BID BULLETIN NO. 3
13 August 2024

**Supply, Delivery, Installation, Testing, Training, and
Commissioning of Closed-Circuit Television (CCTV) for the
People's Television Network, Inc. (PTNI)
ITB No. 2024-0004**

ANNEX A

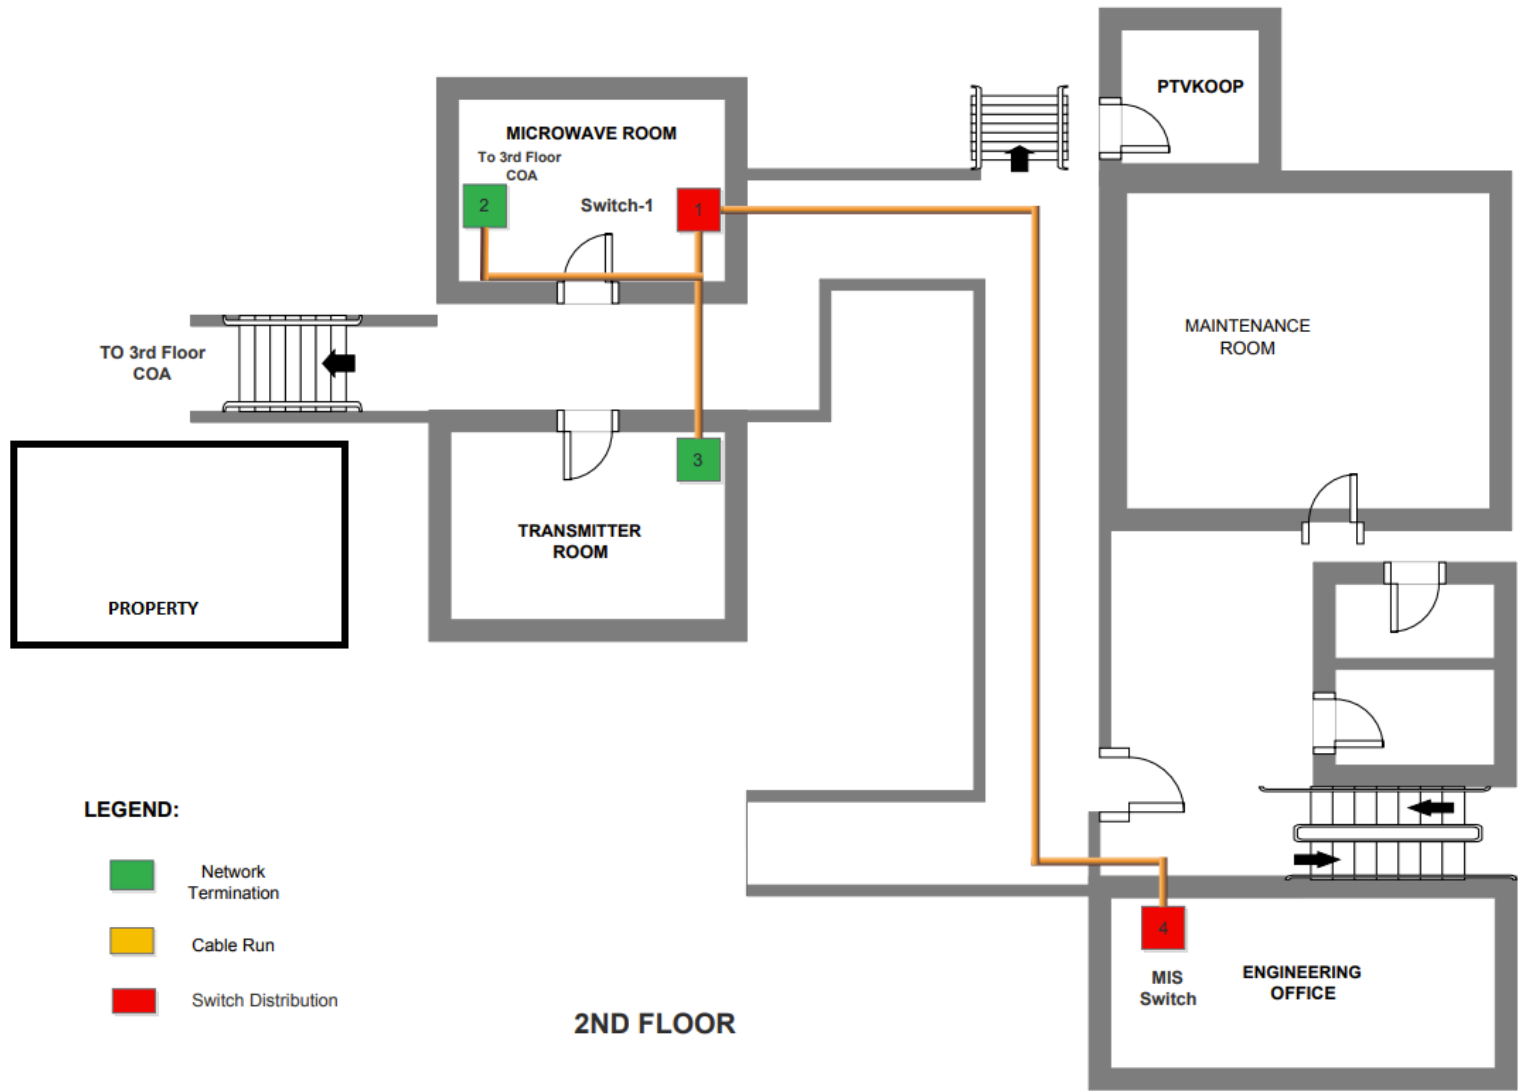
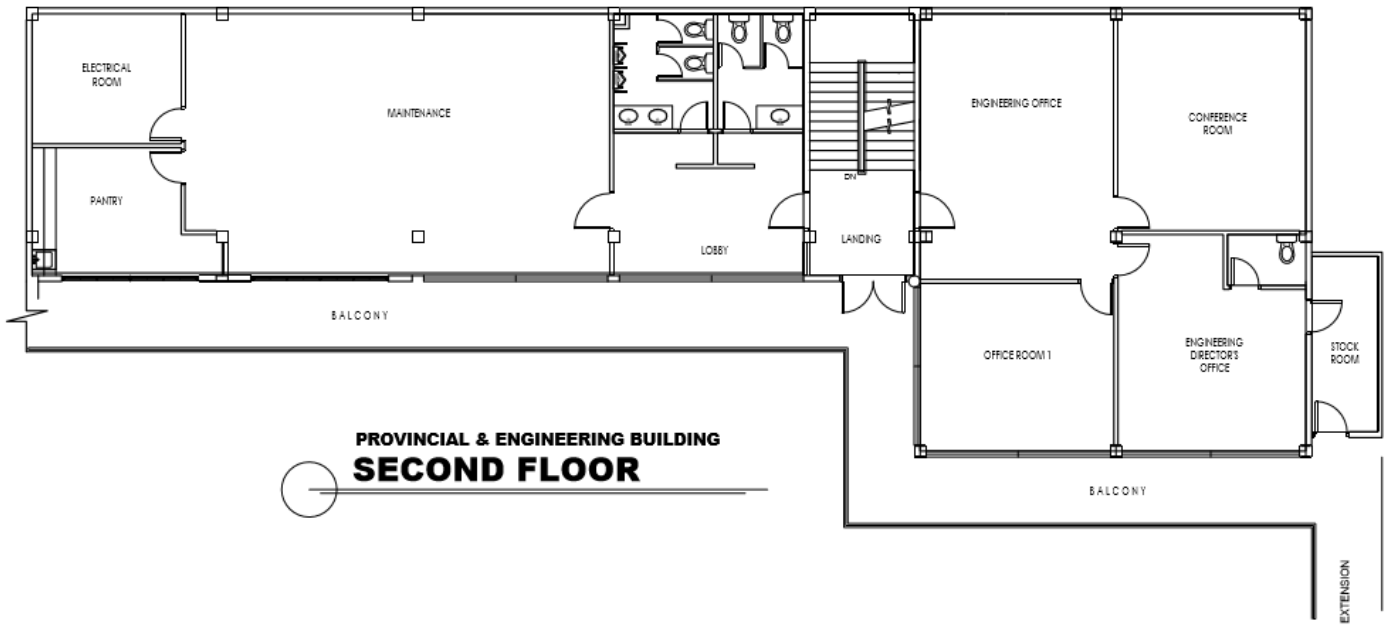
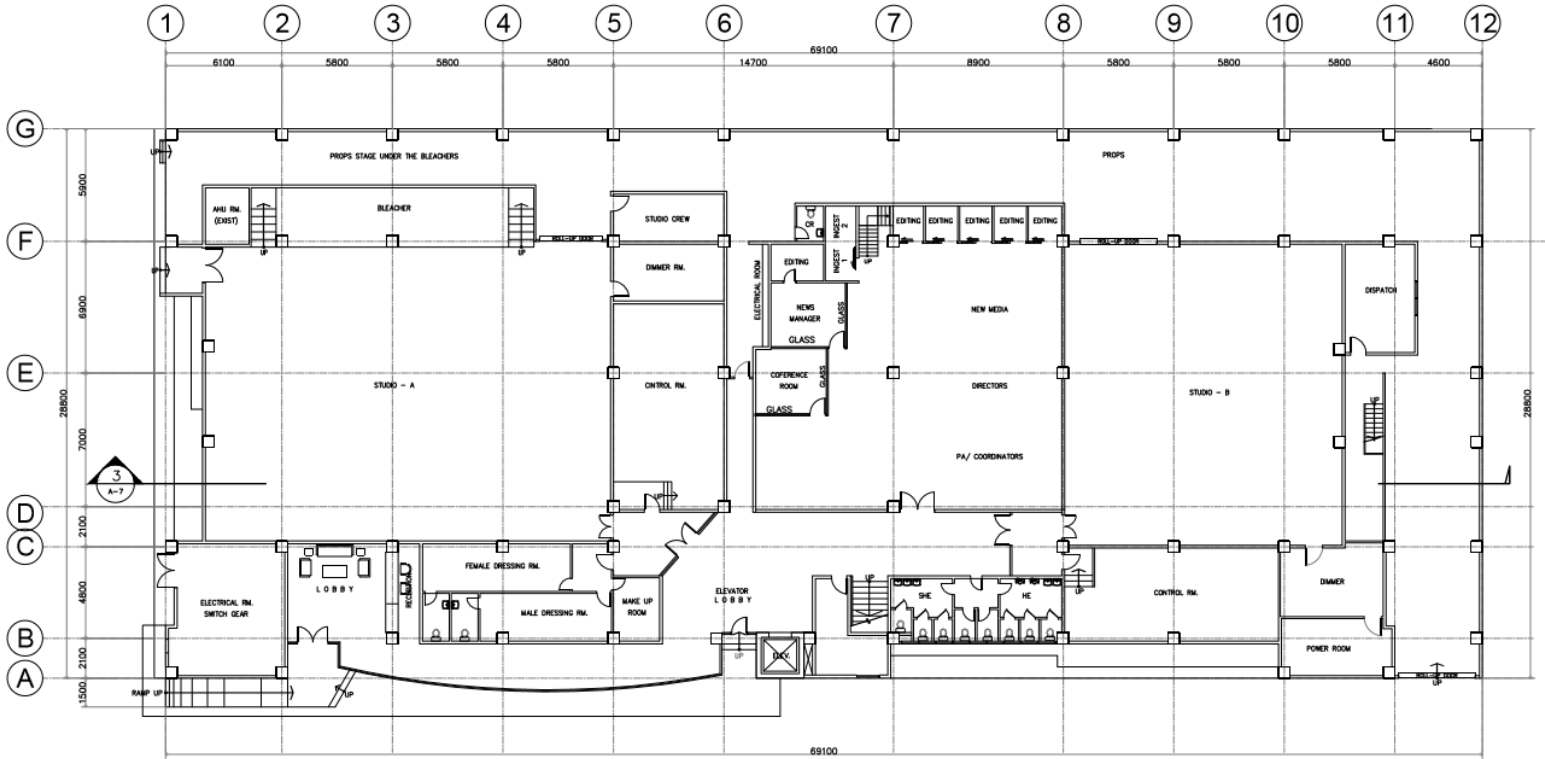
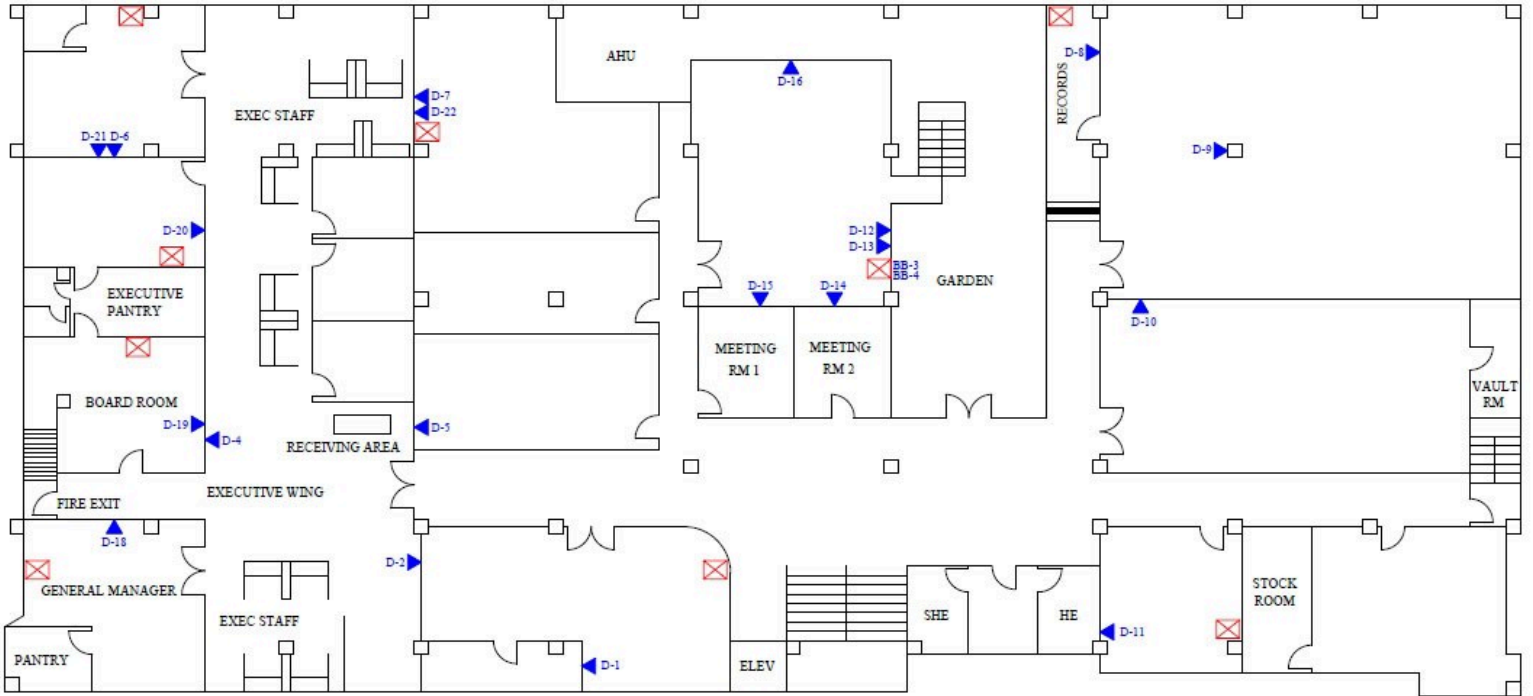
20	Will the Surveillance Monitor (55") run for 24/7?	Yes
21	Will the Network Video Recording (NVR) 64CH run 24/7 monitoring?	Yes
22	Will the end-user provide a floor plan and camera location to the bidders?	Please see Annex "A"
